Bulletin #6 of 2022. May 31, 2022

CHANGE TO PRODUCT BULLETIN

P/N 550-549 Balance Spacer Now Uses One O-ring

Previous balance spacer with two O-ring slots, left, and current with one, right.

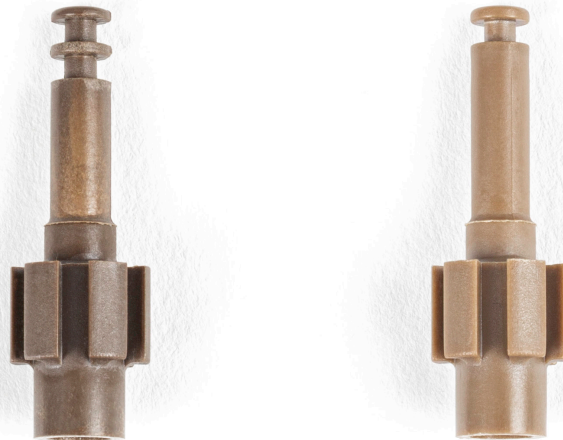
The Balanced Spacer will be manufactured to receive and use only one O-ring instead of two. This change will take place as soon as our stock of the Balance Spacer that accepts two O-rings runs out.

Any old stock of the Balance Spacer that is configured with two O-rings can be used without issue.
